Addendum No. 2 – Mexico Beach Pier

November 10, 2025

2 RESTROOM ELEVATION - FRONT
1/2" = 1'-0"

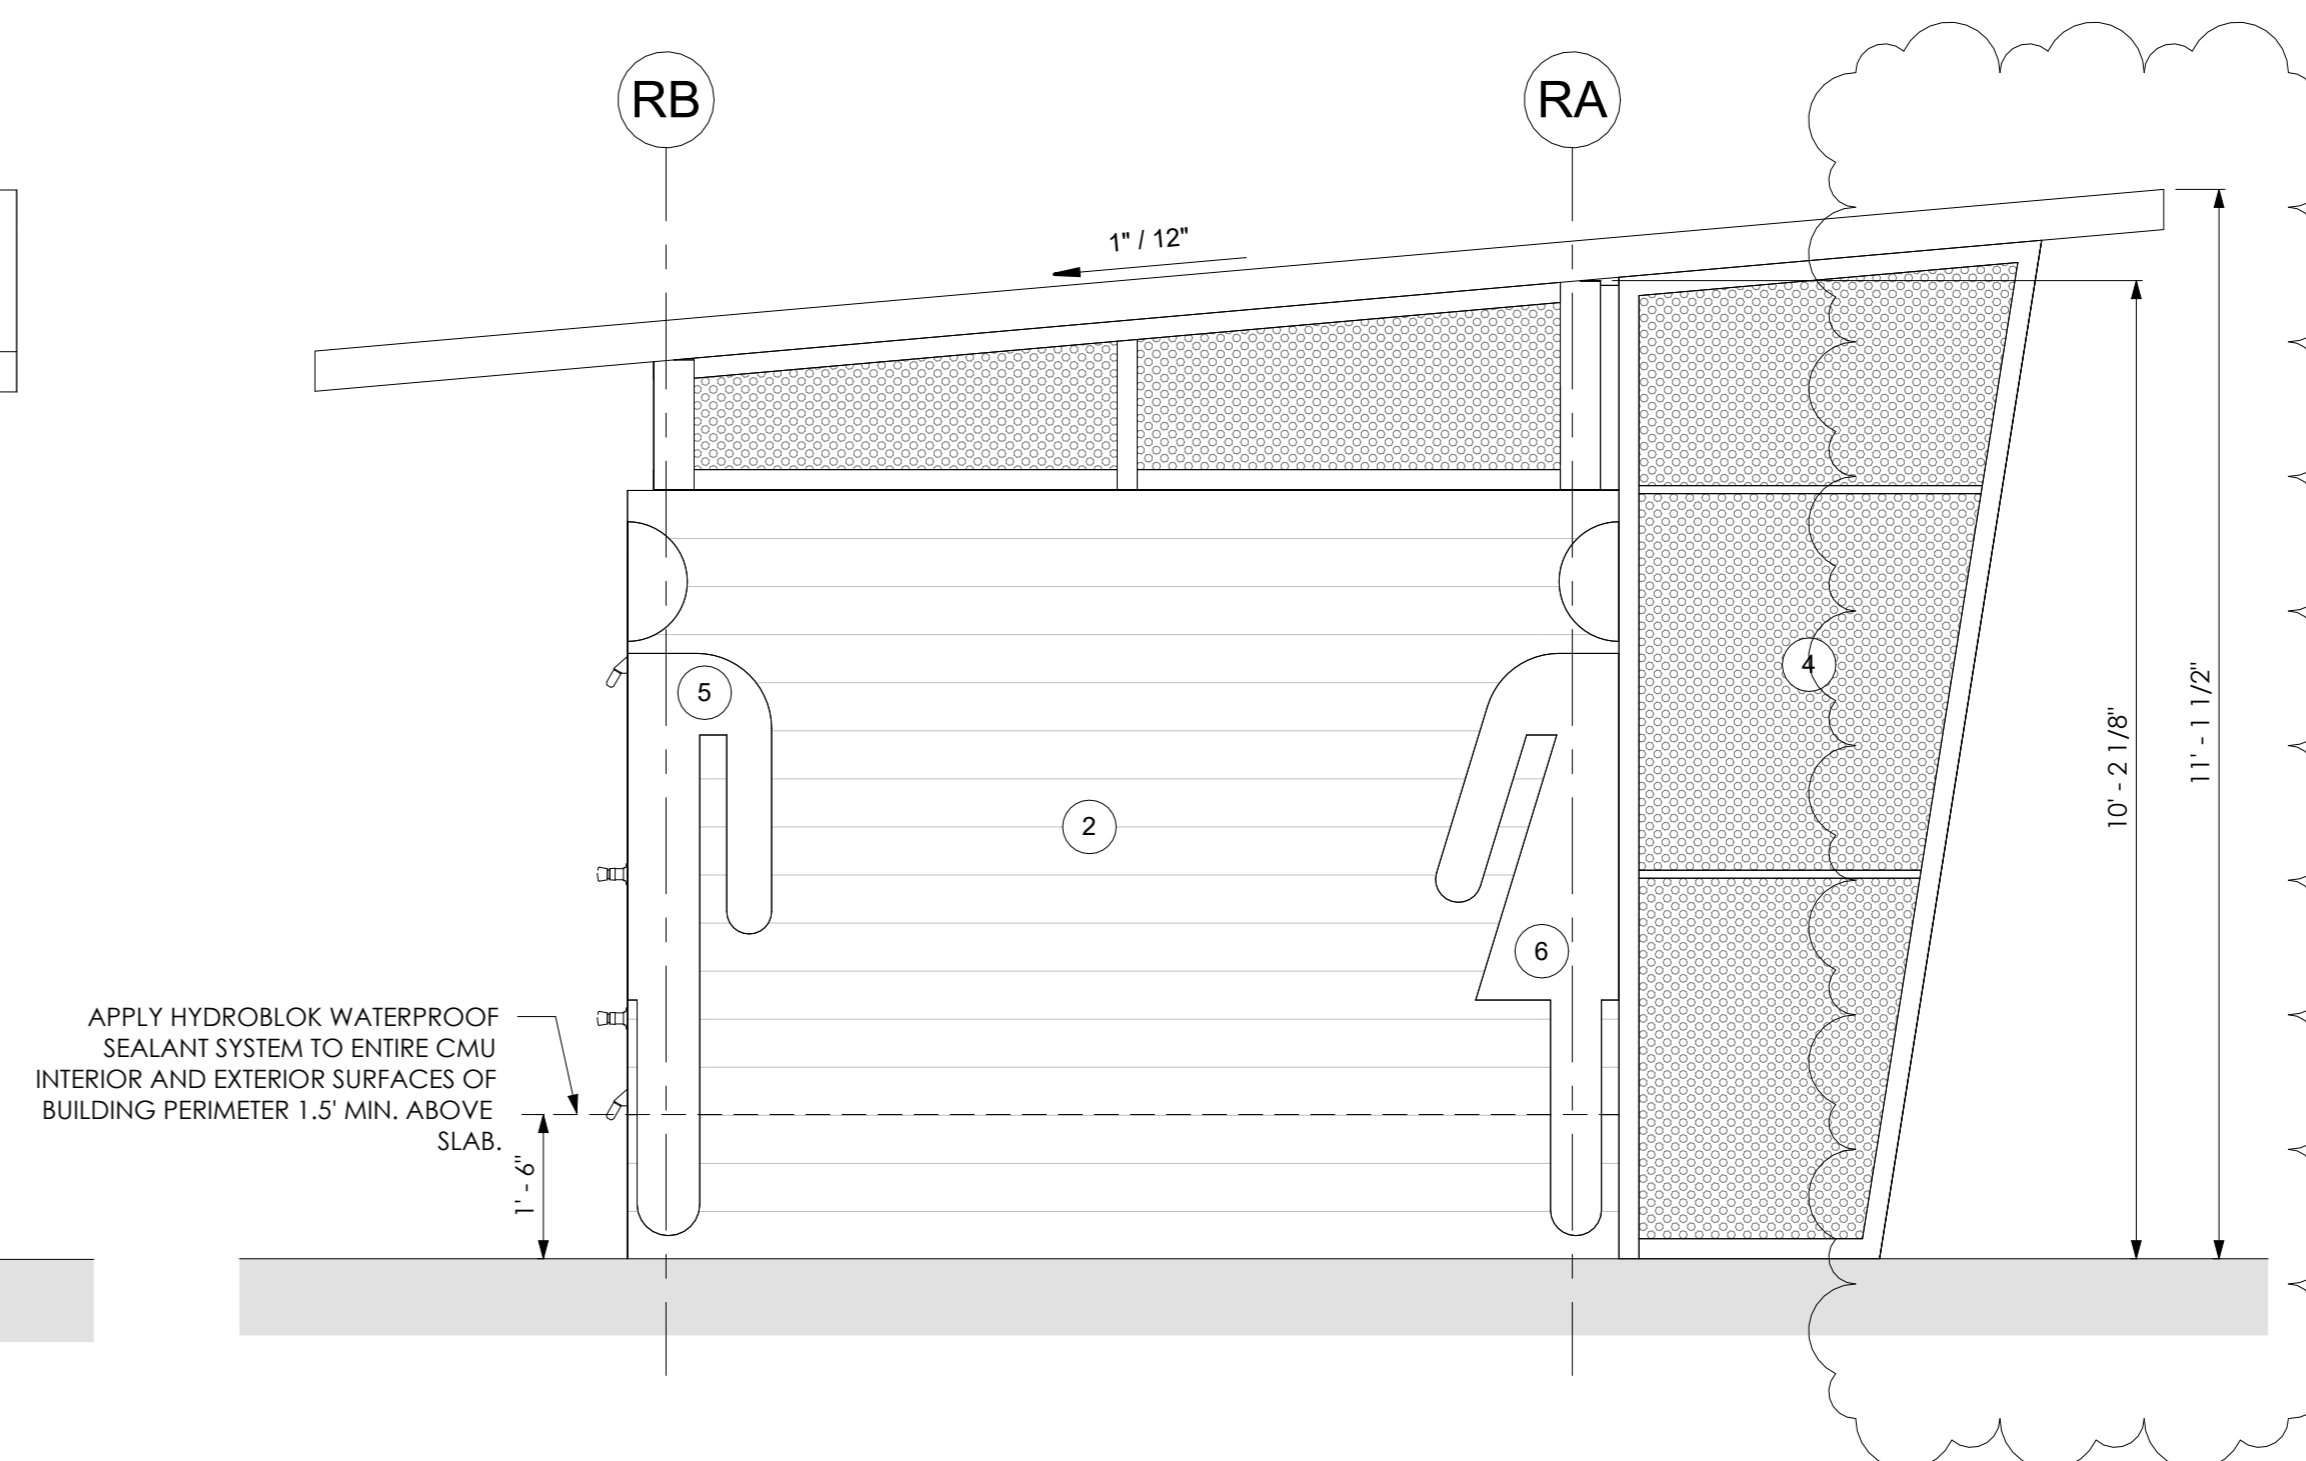
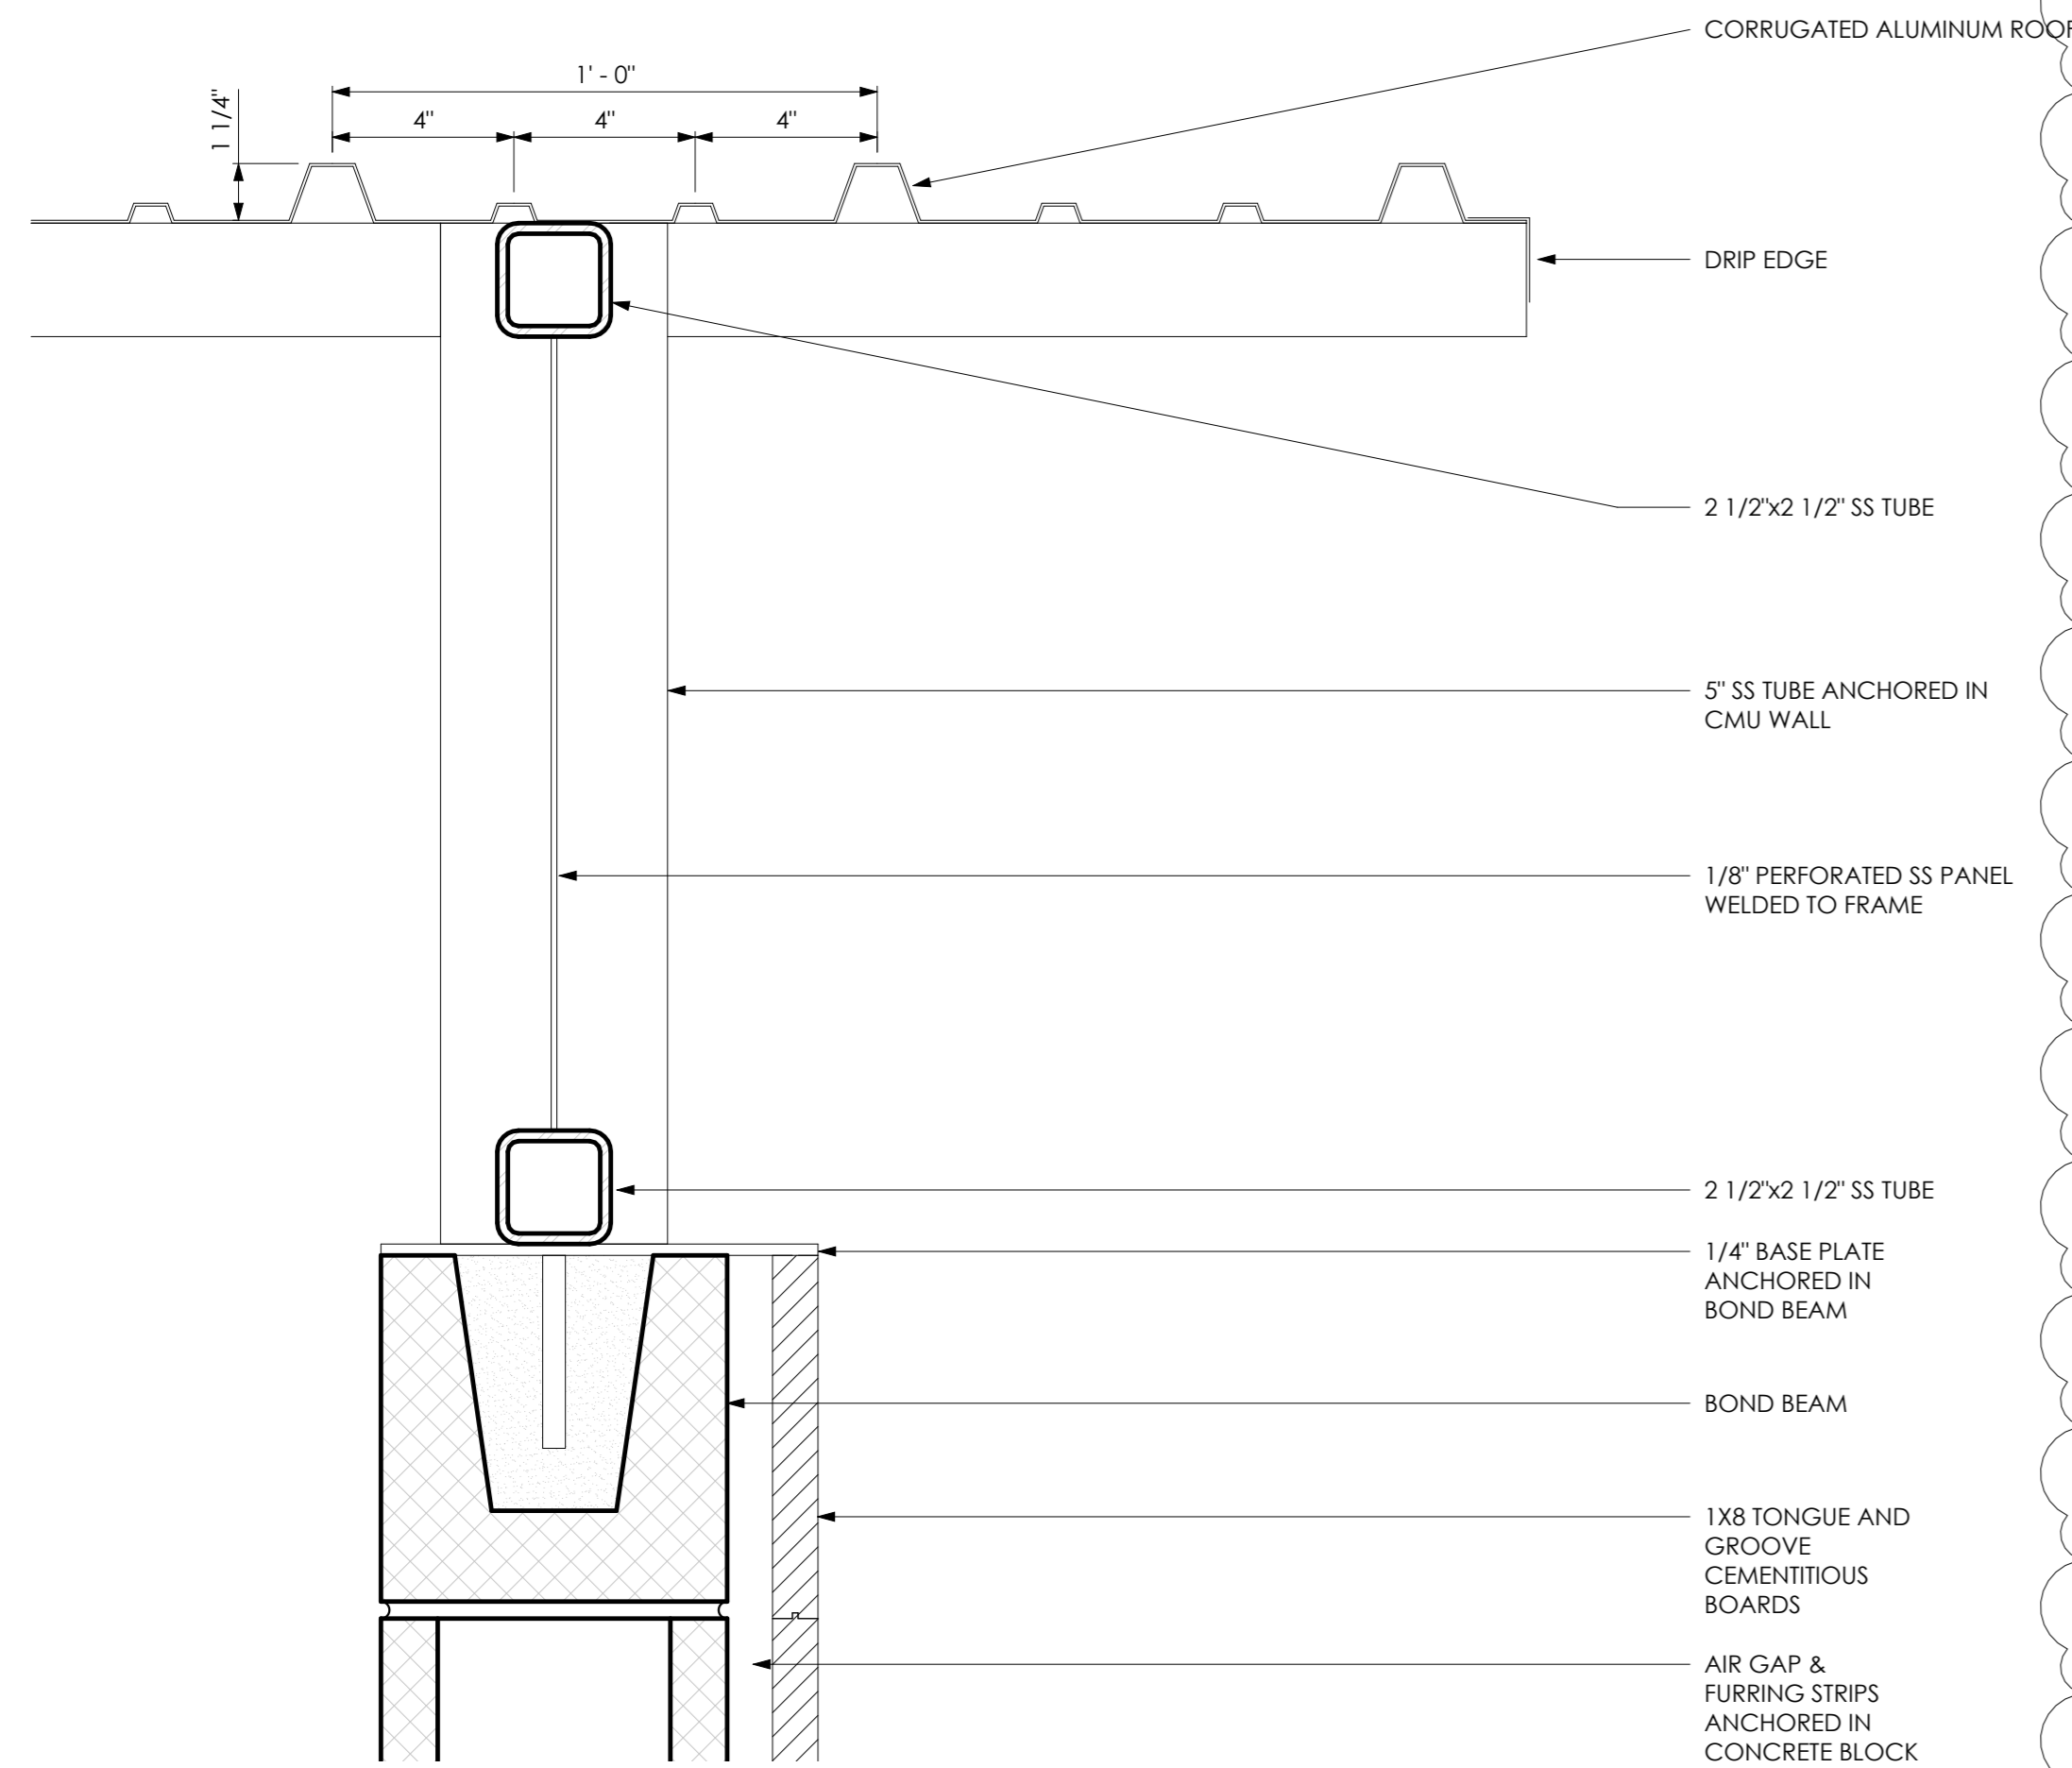
14. Plans for the restrooms call for aluminum and SS roof. Please clarify which roof is preferred.

15. There are no heights on the elevations for the restrooms. Please provide elevation dimensions for the restrooms.

Please see the revised Architectural Plans.

Please see the revised Architectural Plans.
